Date: 09/13/00

Re: Aspen CDP Board Rev. 1.3 - Board Issues/Errata

Figure 1

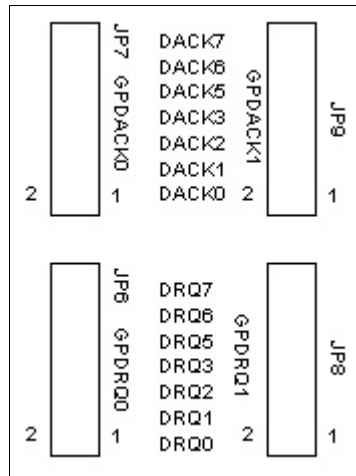
Problem The silkscreen for JP6, JP7, JP8, and JP9 is incorrect.

The signals DRQ0, DRQ1, DRQ2, and DRQ3 on JP6 and JP8 are incorrectly labeled as DRQ1, DRQ2, DRQ3, and DRQ4 respectively.

The signals DACK0#, DACK1#, DACK2#, and DACK3# on JP7 and JP9 are incorrectly labeled as DACK1#, DACK2#, DACK3#, and DACK4# respectively.

The labels ISA1 and ISA0 that identify the JP6/JP7 and JP8/JP9 jumper blocks are incorrect. They should be removed entirely.

JP6 should be labeled GPDRQ0, JP7 should be labeled GPDACK0, JP8 should be labeled GPDRQ1, and JP9 should be labeled GPDACK1.

Relabel the jumper headers. Refer to figure 1.

Change the silkscreen to correct the labeling error. It should appear exactly as the schematic indicates with the top-down view on page 15 (with the exception of the ISA0 and ISA1 labels being removed and the GPDACK0, GPDACK1, GPDRQ0, and GPDRQ1 labels being added). Refer to figure 1.

Figure 2

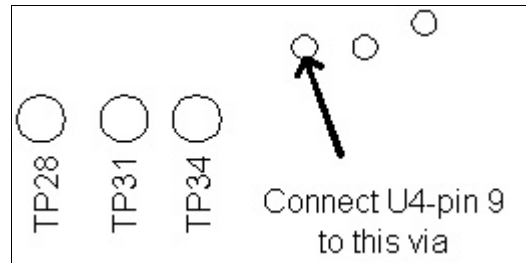
Problem DMA from the IDE interface does not work. The data transceiver, U23, is not enabled by the PAL, U4, during an IDE DMA transfer. In addition, the IDE Data Bit 7 is not activated properly during a DMA cycle.

To fix this problem, the PAL needs a signal indicating that an IDE DMA cycle is in progress. The equations for the data transceiver enable outputs on the PAL must be changed to activate the enable signals during an IDE DMA cycle. In addition, the IDE Data Bit 7 must be properly activated for read or write during an IDE DMA cycle.

Cut trace from the VIA to U4-pin 9.

Wire from the via indicated in Figure 2 to U4-pin 9. This puts the signal IDE DACK# onto pin 9 of the PAL for use in the equations.

(This step is an alternative to the previous step, either connect from the via or from the backside of the board, but not both.) Wire from P4-pin 20 to U4-pin 9. Run the wire through the hole in the board for TP32, which is located right next to U4.

Reprogram the PAL with the Revision 1.3 Equations (*see rework 1.3.4*), which adds terms for asserting the missing IDE signals whenever IDEDACK# is asserted.

Delete the signal GPAEN from the U4 PAL and instead put the signal IDEDACK# onto pin 9.

Figure 3

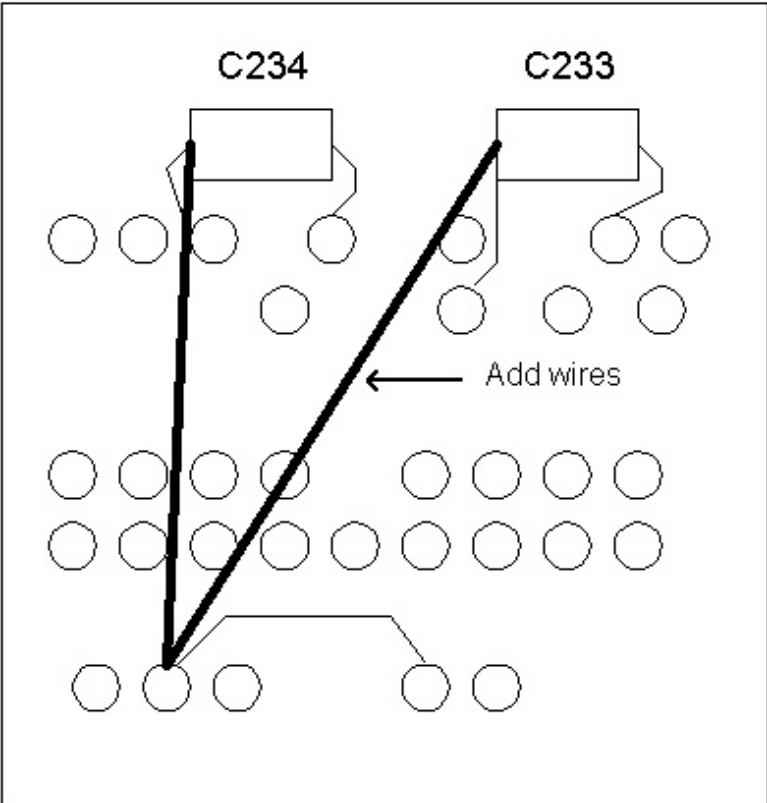
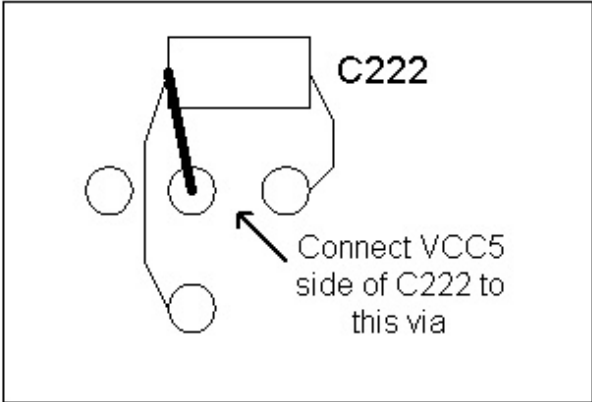
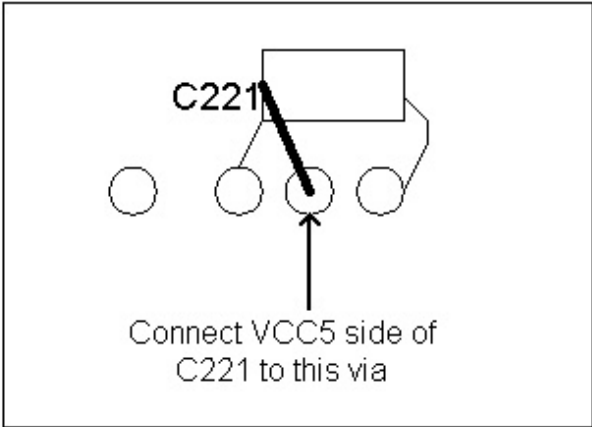
Problem 16 of the 32 memory data signals are not visible on the SDRAM Header. The buffer (U44) that is connected between the SDRAM header (P7) and these signals is not connected to VCC5.

Pins 7, 18, 31, and 42 on U44 are connected to C221 and C222 through a trace that spans across the entire board. U44 should be utilizing C233 and C234 as its source of filtered power, as they are located near U44. The VCC5 side of these capacitors should be connected directly to pins 7, 18, 31, and 42 of U44 through a via. The VCC5 side of C221 and C222 should be connected to pins 7, 18, 31, and 42 of U43 (a buffer for the PCI Header) through a via, as they are local to that chip and should be used to filter its power.

See figure 3.

Wire from U44 pin 42 via to VCC5 side of C233 and C234.

Wire from U43 pin 18 via to VCC5 side of C221.

Wire from U43 pin 42 via to VCC5 side of C222.

Connect VCC5 to C221, C222, and U44 pins 7, 18, 31, and 42.
